VEHICLE RECALL

G-03503 March 2003

SUBJECT: SAFETY RECALL (U.S., EXPORT)

Limiting the forward travel on the driver's seat by installing a stop-bracket on the adjuster track for 4700 models built from 12/13/94 through 9/4/98.

Figure 1

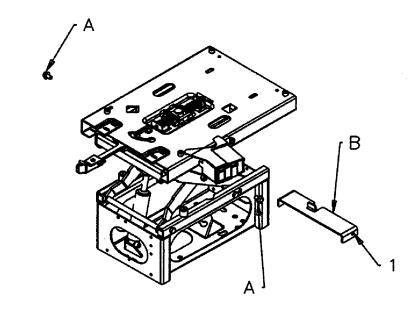
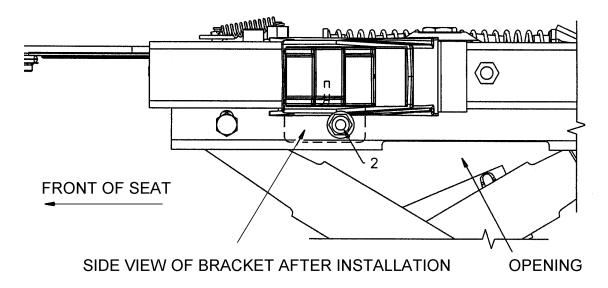
INTRODUCTION: This procedure is for the installation of a seat stop-bracket on the driver's seat track to limit the forward travel of the seat so that the seat cannot push the parking brake lever forward and release it. The seat may still touch the parking brake lever when the lever is in the brake-set-position and the seat is all the way forward; however, the seat will not travel forward enough to release the lever.

- 1. Park the vehicle on level ground, put the transmission in neutral, set the parking brake and shut off the engine.
- 2. Slide/adjust the driver's seat as far back as it will go (most rearward position).
- 3. Raise the seat to the highest position.
- 4. Insert stop-bracket "B", in the orientation as shown in Figure 1, through the opening in the top of the seat suspension.
- 5. Align hole "1" in the stop-bracket with hole "2" in the upper plate of the seat suspension.
- 6. Insert screw "A" into hole "2" but do not tighten (use a ½" socket).
- 7. Repeat steps 6 and 7 for the other side of the stop-bracket.
- 8. Tighten both screws to 20 Lb-Ft or 27 NM.

With the parking brake set, stand outside the vehicle, slide the driver's seat all the way forward and verify that the seat will stop before releasing the parking brake lever.
